# Access Compliance Report

## Public Rights-of-Way

### (Curb Ramps)

Intersection ID: 13149	Main Street: CENTRAL_AV	Cross Street: THE_PLAZA	Location: SW
ADA ID: B8FCE7CAC410	Ramp Type: Perp	Initial Pass/Fail: Fail	Overall Compliance: No
Severity Score: 43.75			
Codes/Mitigation Info/Possible Solution		Field Measurements/Component Compliance

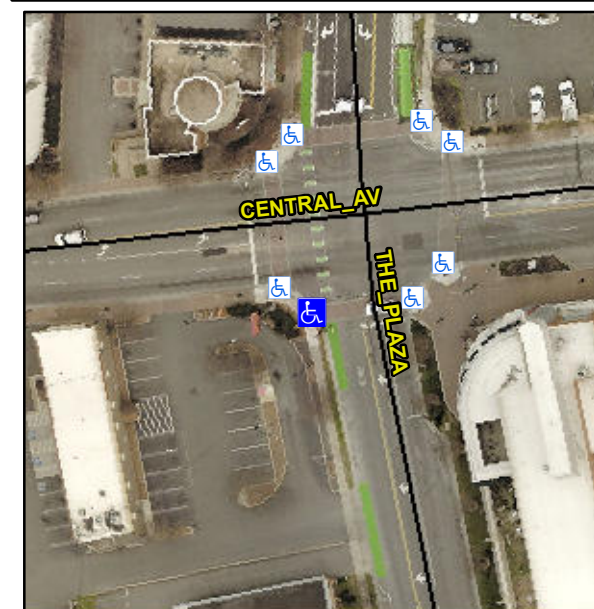
**Not Found, R304.5.1, R304.2.2, R304.5.3**

Compliance	Description	Data	Compliance	Description	Data
N/A	Ramp Length (in)	65.0	No	Ramp Slope (%)	18.6
No	Ramp Width (in)	33.0	No	Ramp XSlope (%)	2.7
N/A	Flare Type LT	N/A	N/A	Flare Type RT	N/A
N/A	Flare Slope LT (%)	N/A	N/A	Flare Slope RT (%)	N/A
N/A	Flare Traversable LT?	N/A	N/A	Flare Traversable RT?	N/A
N/A	Landing Length (in)	N/A	N/A	DWS Provided?	N/A
N/A	Landing Width (in)	N/A	N/A	DWS Contrast?	N/A
N/A	Landing Slope (%)	N/A	N/A	DWS Length (in)	N/A
N/A	Landing X Slope (%)	N/A	N/A	DWS Full Width?	N/A
N/A	Landing Curb? (Y/N)	N/A	N/A	DWS Offset (in)	N/A
N/A	Shared Landing?	N/A			
N/A	Gutter Ponding?	N/A	N/A	Gutter Slope (%)	N/A
N/A	Gutter Lip Ht (in)	N/A	N/A	Gutter X Slope (%)	N/A
N/A	Painted X Walk1?	Yes	N/A	Painted X Walk2?	N/A
	X Walk 1 Direction	To E		X Walk 2 Direction	N/A
N/A	X Walk 1 Width (in)	96.0	N/A	X Walk 2 Width (in)	N/A
	X Walk 1 Slope (%)	3.4		X Walk 2 Slope (%)	N/A
	X Walk 1 X Slope (%)	0.2		X Walk 2 X Slope (%)	N/A

**Remove & Replace Entire Ramp.**
